ADC PARKS & GREENSPACE ARBORICULTURE

PLANNING APPLICATION: AW/357/14/T

ADDRESS: 7 The Ridings Bognor Regis PO21 4HP

BRIEF DESCRIPTION: Cut back to previous pruning points 4No. Lime trees

Figure 2 Positions of final cuts

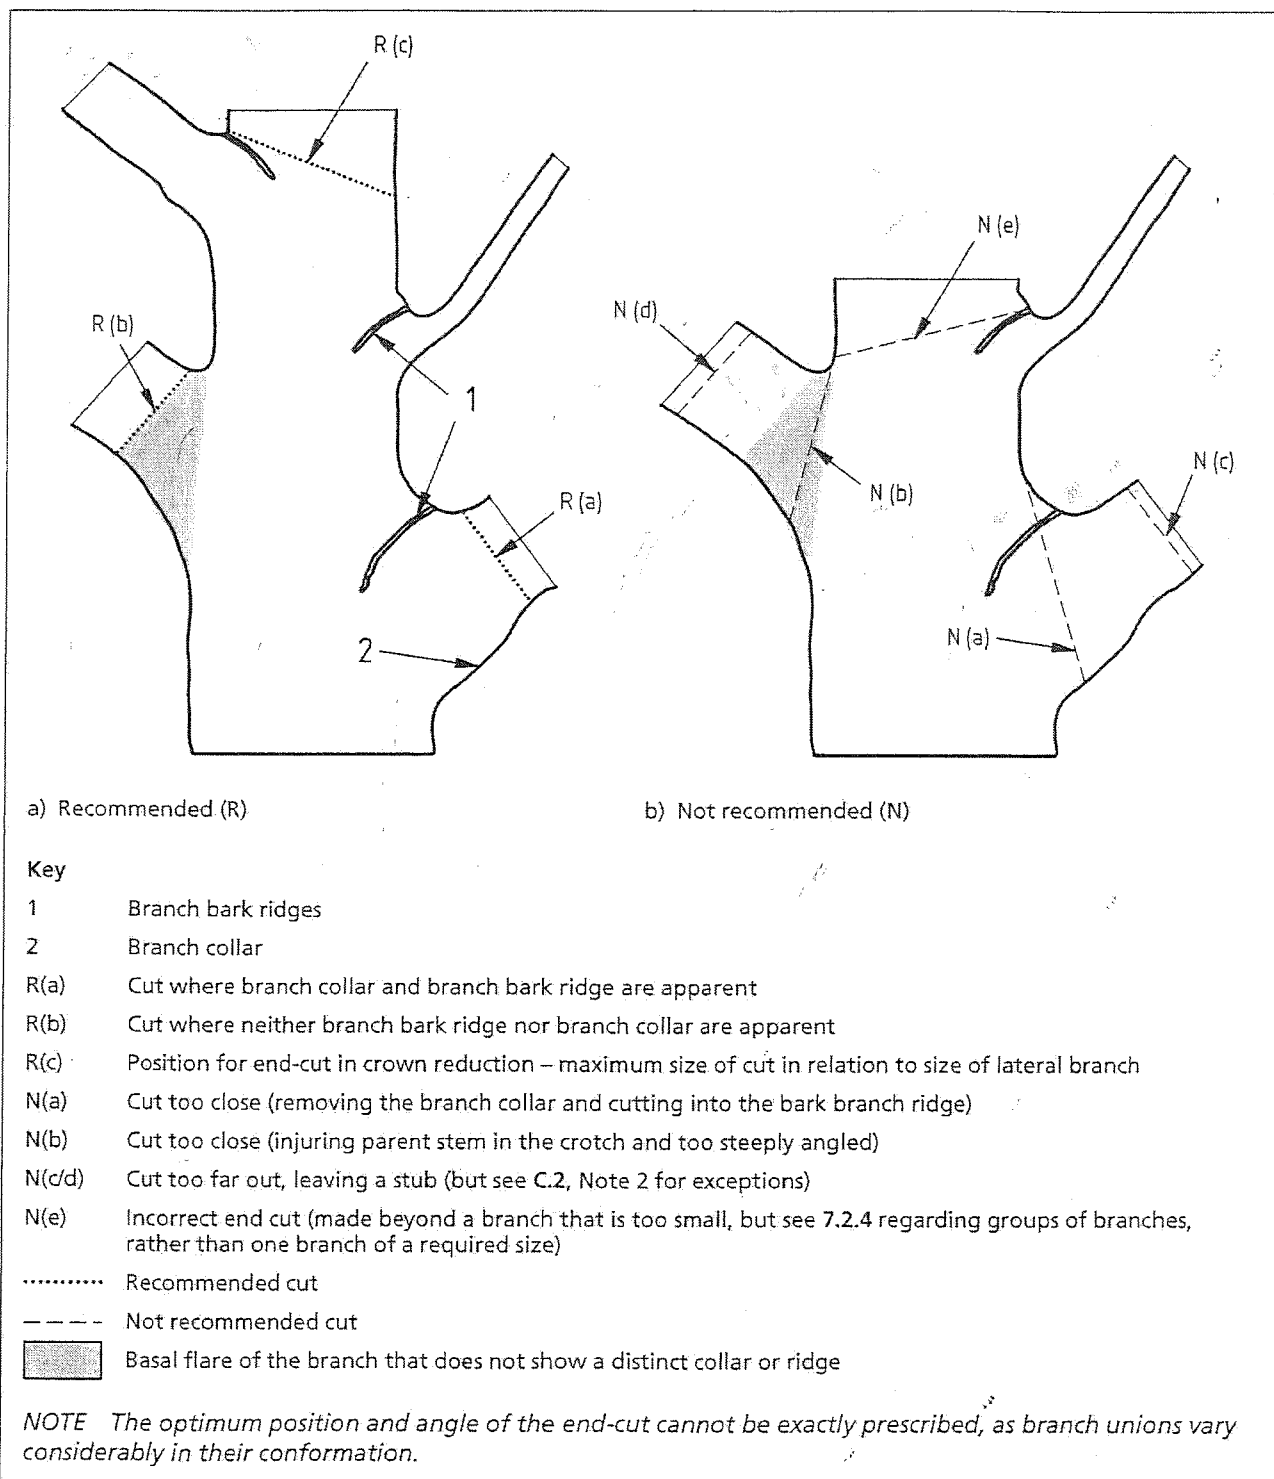
All side branches to be retained should be at least **1/3rd** in diameter of the removed branch. Pruning cuts must be flat and smooth, kept as small as possible by cutting at an optimum angle and should not exceed **100mm** in diameter.

Figure 4 Diagrammatic illustration of crown reduction

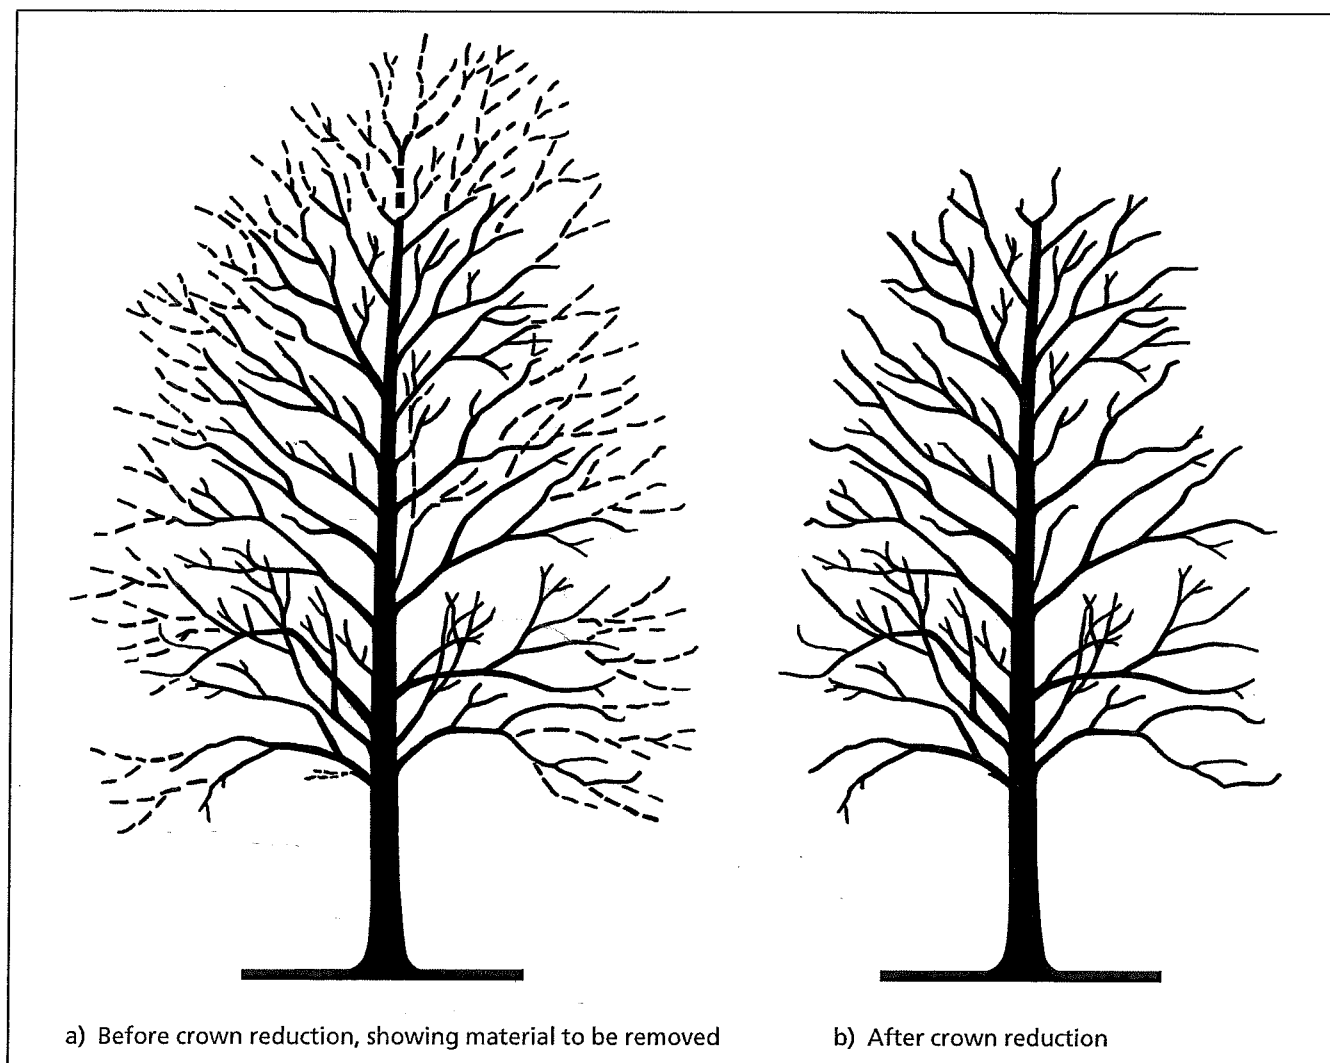
Crown Reduction
